MCPB
ITEM NO. 12
5-18-06MEMORANDUM

Project: Metropolitan Branch Trail, Phase I Facility Planning
Montgomery College Takoma Park/Silver Spring Campus to Silver Spring Transit
Center

Review Type: Project Prospectus

Applicant: Montgomery County Department of Public Works and Transportation

OPTION 1

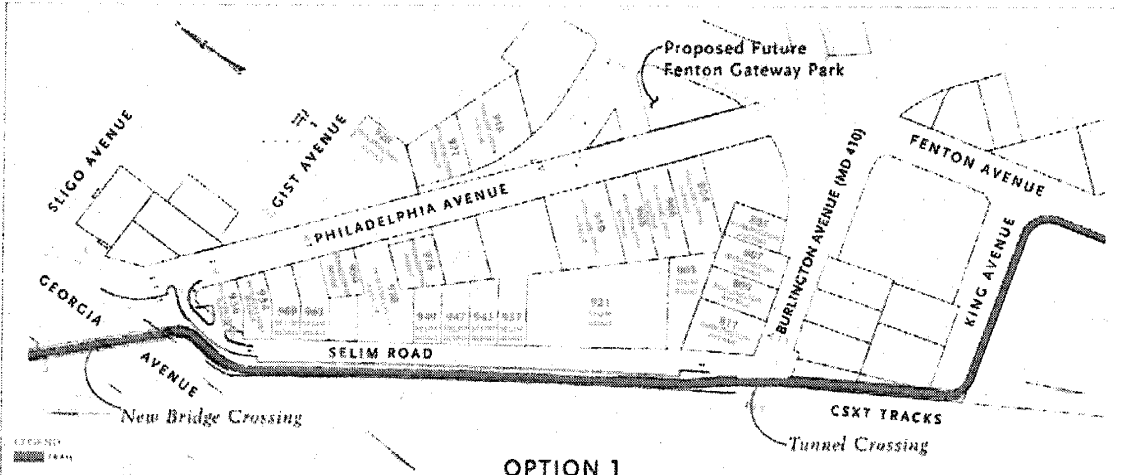
- **Option 1** is the master plan alignment studied and endorsed by the Planning Board in 2001. It includes a new separate pedestrian/bicycle bridge over Georgia Avenue and a new pedestrian/bicycle tunnel under Burlington Avenue (MD 410). Selim Avenue would be narrowed to accommodate the parallel trail and the intersection of Selim and Philadelphia avenues would be realigned to accommodate the new bridge landing. The proposed alignment also would require a retaining wall between Selim Avenue and the railroad right-of-way where steep grades exist.

- Cost estimate: \$17M - \$22M.
 - Comments and Analysis: The study concluded that this alignment is still the preferred alignment in the long term. Full grade separation at both Georgia and Burlington Avenues would guarantee a high quality trail-user experience consistent with the Capital Crescent Trail and most sections of the Metropolitan Branch Trail in the

District of Columbia. However, the study concluded that the tunnel under Burlington Avenue may be very costly and the site very constrained due to proximity to the railroad right-of-way and existing supports for the Burlington Avenue overpass/bridge.

The Option 1 tunnel would also have expected operating budget impacts to the Silver Spring Urban District (SSUD) that would be responsible for regular maintenance. The SSUD repeated has stated that it does not support the tunnel and would prefer not to assume daily maintenance (sweeping, cleaning, trash removal, etc.) if and when the tunnel is ever built. Because the tunnel is located in an area not clearly visible from public areas and rights of way, the SSUD fears the tunnel may become a gathering spot for illegal activity and related squalid elements.

Staff also believes that personal safety issues need to be resolved, not just for the tunnel itself but also for the tunnel approach on King Street, which is not a through street and has no street-activating land uses. In the short term, staff does not believe it is worth pursuing the tunnel. However, in the long term the tunnel could be implemented when the Burlington Avenue bridge is fully replaced by State Highway Administration (SHA). At that time, the trail could be realigned by either the County or SHA to connect trail segments to the tunnel.

OPTION 2

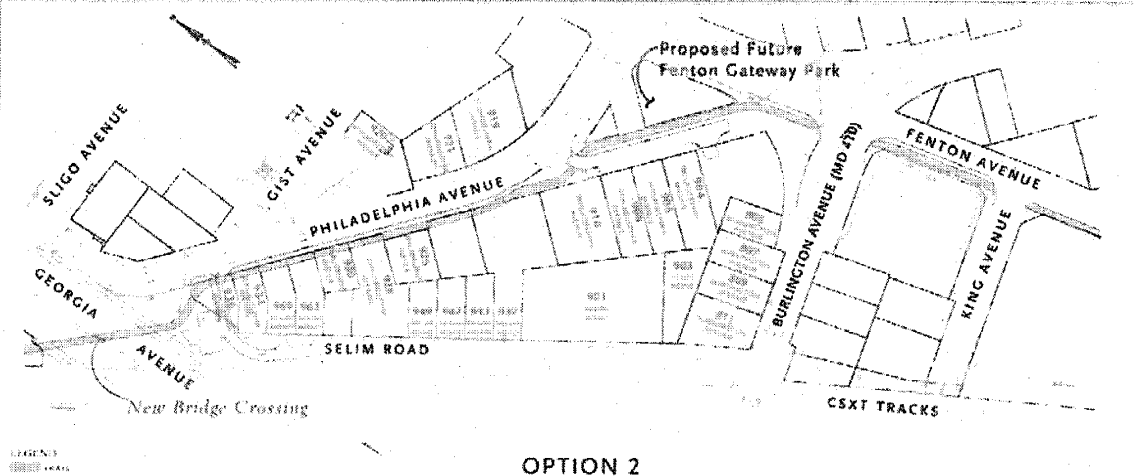
- **Option 2** takes the trail over Georgia Avenue on a new bridge landing just south of Philadelphia Avenue, then jogs north along Selim Avenue to connect to Philadelphia Avenue. The path runs along the south side of Philadelphia Avenue in the master planned right-of-way, impacting nine properties. Philadelphia Avenue would not be redesigned or reconfigured. The path would bisect the future Fenton Gateway Park before crossing Burlington Avenue and heading south toward the College campus.

- Cost Estimate: \$11M - \$14M.
 - Staff comments and analysis: This alignment is not desirable due to required property acquisitions along Philadelphia Avenue, as well as adverse impacts on the current and future land uses along Philadelphia Avenue. The off-road trail would run along the property frontages of numerous automobile-oriented businesses, and as a result, cars would likely be frequently parked on or across the trail. Enforcement would be a persistent problem. Staff believes this Option would cause as many problems as it solves.

OPTION 3

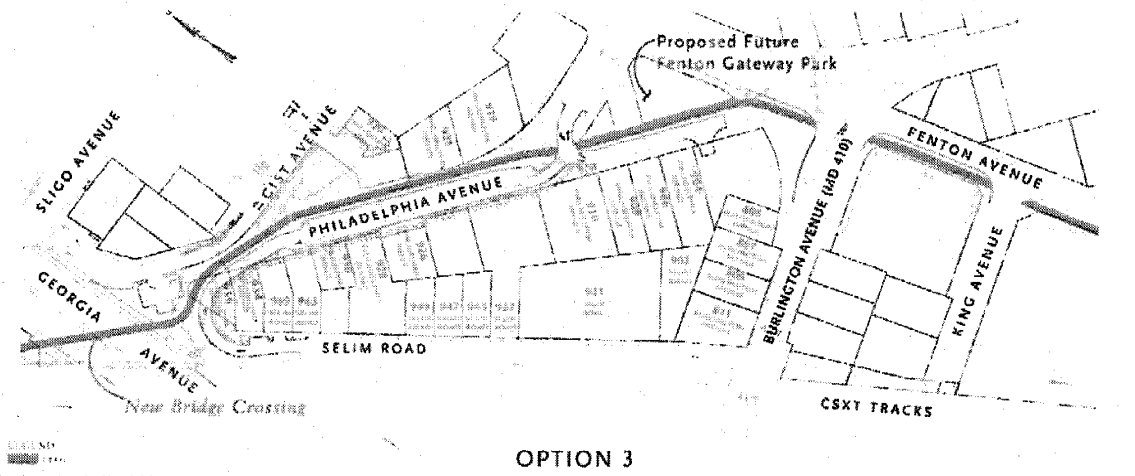
- **Option 3** is similar to Option 2, except the trail would run along the north side of Philadelphia Avenue and require the redesign and reconstruction of the entire road, making it one-way eastbound with perpendicular parking spaces. The option would also remove the connection between Gist and Sligo Avenues. The alignment would require numerous new driveways along both Philadelphia and Gist Avenues and require two at-grade trail crossings of Philadelphia Avenue as well.

- Cost Estimate: \$14M - \$17M.

- Staff comments: Staff believes redesigning Philadelphia Avenue is unnecessary and undesirable. This option causes the largest number of property impacts. Running the trail along the north side of the road would require two additional at-grade trail crossings, creating two new potential points of conflict. Staff feel this option would cause too much disruption to the area for very little benefit in return.
